Ms. Angela Freudenstein, Environmental Manager
Alaskan Way Viaduct Replacement Project
999 Third Avenue, Suite 2424
Seattle, WA 98104

Re: Alaskan Way Viaduct Replacement Project
2010 Supplemental Draft EIS & Draft Section 4f Evaluation
Comments

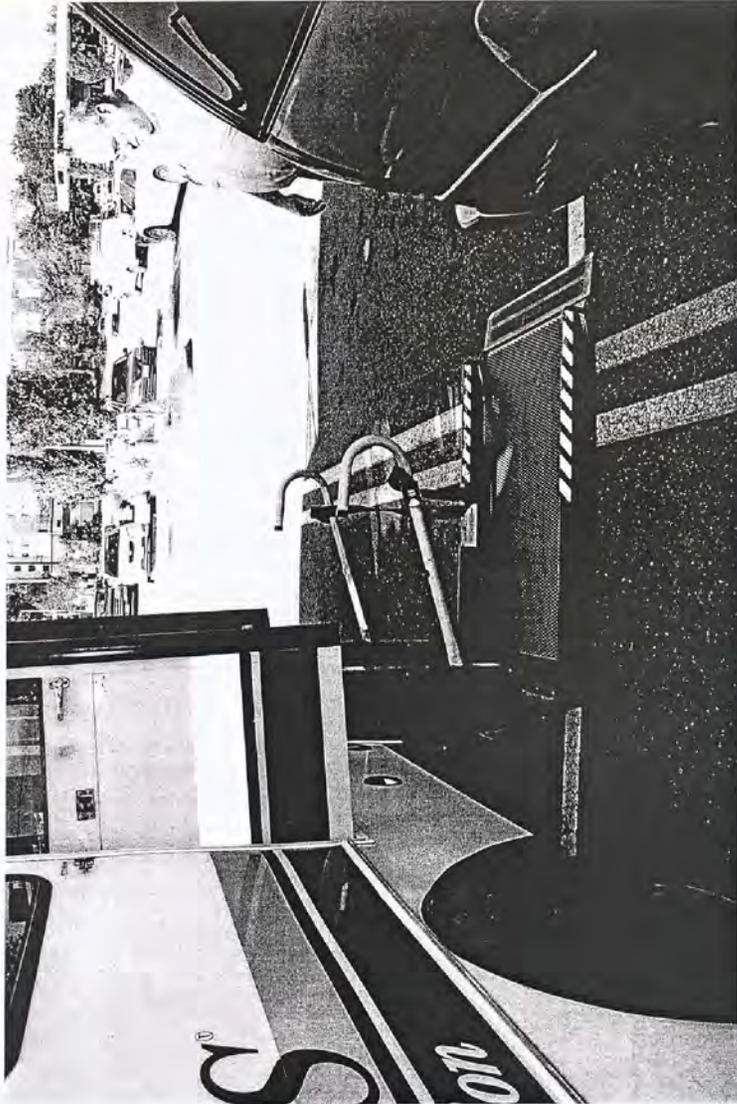
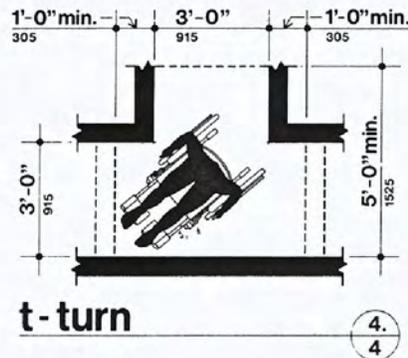
8. In Chapter 3, Exhibit 2-1 shows the design concept of the deep-bore tunnel. The lower roadway of this figure shows the northbound (NB) traffic lanes and a very narrow right hand shoulder. It is obvious that no attention has been paid to the needs of the disabled (such as wheelchair users) in this design, let alone those of the parents of young toddlers who, in the event of an accident and in need of abandoning the lower tunnel, must have enough space to unbuckle their infants from their DOT approved car seats and then get them out of the car and into their strollers or perambulators so they can get to the escape corridor. With such a narrow shoulder it is obvious they, too, have been overlooked. In this regard, note that the described 2-foot shoulder is inadequate since the typical Metro Dial-Ride (DART) mini-bus has a handicapped (HC) access wheelchair (WC) ramp on its right side and that it needs 6 feet of clear space to deploy the ramp. Further, at its WC ramp end an additional 3 feet is required to allow the WC user to get off the ramp and turn left or right. (See the Federally adopted *Minimum Guidelines & Requirements for Accessible Design*, Subpart D – Technical, page 3, Figure 4./4.)

- I-018-017** | travel lanes and a narrow shoulder on the right. These are respectively 6 feet and 2 feet. However, the WSDOT *Design Manual*, at page 1140-9, states, "Shoulders on the left between 4 feet and 8 feet wide are less desirable. A shoulder in this width range might appear to a driver to be wide enough to stop out of the through traffic when it is not. This concern is repeated in the AASHTO *Policy on Geometric Design of Highways and Streets*, 2001 edition, page 459, where it states, "Shoulder space on the left side ... is not intended to serve the same purpose as the right shoulder. The shoulder on the right, through customary use ... is accepted by all drivers as a suitable refuge space for stops." It is remarkable that WSDOT is yet again, on this corridor, deviating from current, adopted standard engineering practice. Consequently, this leads to an obvious question that must be answered in the Final SEIS. Why is standard engineering practice being discarded in the tunnel design and, in terms of highway safety, what will be the adverse consequences from such a deviation?

The Alaskan Way Viaduct Project is subject to compliance with the American Disabilities Act (ADA) so the final design of the project will meet all the necessary ADA requirements. Roadway shoulders are not subject to ADA requirements in areas where pedestrians are prohibited. Current project design allows for a 2-foot shoulder on one side and an 8-foot shoulders on the other side of the roadway in the bored tunnel. The 8-foot shoulder is a reasonable width for vehicles to pull off the road in case of emergency. Whether a wheelchair accessible van can unload entirely within the shoulder will depend on the type of wheelchair lift with which it is equipped.

The shoulder widths inside the bored tunnel have been modified since the 2010 Supplemental Draft EIS. The tunnel would have a 2-foot-wide-shoulder on one side and an 8-foot-wide shoulder on the other side. Please see our responses to other similar comments in your letter. In short, we believe that it correct to say that the Bored Tunnel Alternative would improve public safety compared to the existing viaduct structure that also has many aspects that deviate from current roadway standards. For example, much of the viaduct and Battery Street Tunnel does not
